Re: Dunkin donuts Renovation
5502 4th St., NW
Traffic Circulation Layout
Engineer's/Architect's Stamp **3-15-16** (F14-D013)

Based upon the information provided in your submittal received 6-27-16, the above referenced plan cannot be approved for Building Permit until the following comments are addressed:

SCHEMATIC SITE PLANS AND TRAFFIC CIRCULATION LAYOUT

Figure 1. Mini Clear Sight Triangle

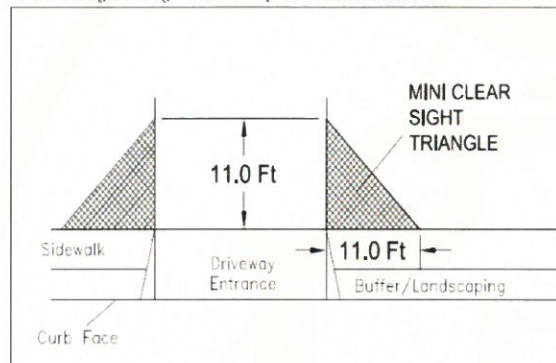
10. Provide a min 6" or max 8" high concrete barrier curb or other acceptable barrier between landscaping and parking areas and/or drive aisles. Please call out detail and location of barrier curb.
11. Service vehicle and/or refuse vehicle maneuvering must be contained on-site; provide a copy of refuse approval.
12. One-way vehicular paths require pavement directional signage and a posted "Do Not Enter" sign at the point of egress. Please show detail and location of posted signs.
13. Please provide a sight distance exhibit (see the *Development Process Manual, Chapter 23, Section 3*). Please show this detail for the intersection of 4th St. and Sanchez Rd. Please show the Mini Clear Sight Triangle detail for the other entrances off of 4th St. and Sanchez Rd.

14. Please add the following note to the clear sight triangle: "Landscaping and signage will not interfere with clear sight requirements. Therefore, signs, walls, trees, and shrubbery between 3 and 8 feet tall (as measured from the gutter pan) will not be acceptable in this area."
15. Unused curb cuts must be replaced with sidewalk and curb & gutter. A build note must be provided referring to the appropriate City Standard drawing.

8	H.C. SIGN DETAIL
N.T.S.	NOTE:

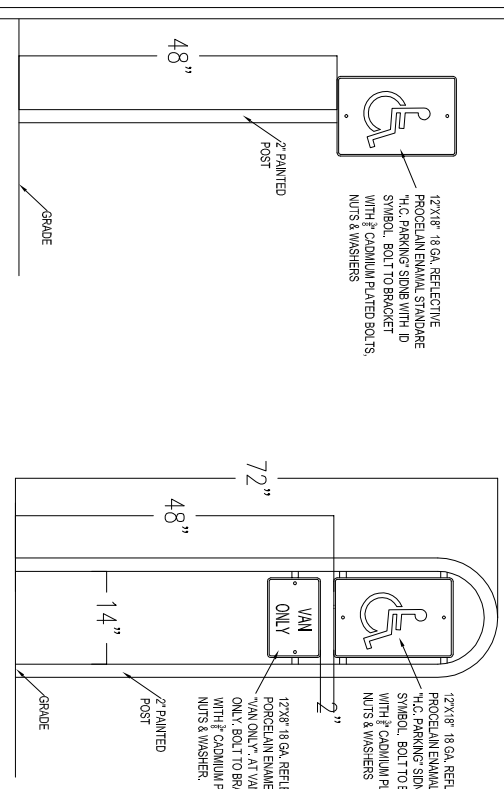
6. The ADA accessible parking sign must have the required language per 66-7-352.4C NMSA 1978 **"Violators Are Subject to a Fine and/or Towing."** Please call out detail and location of HC signs. Please show a detail or call out this language.
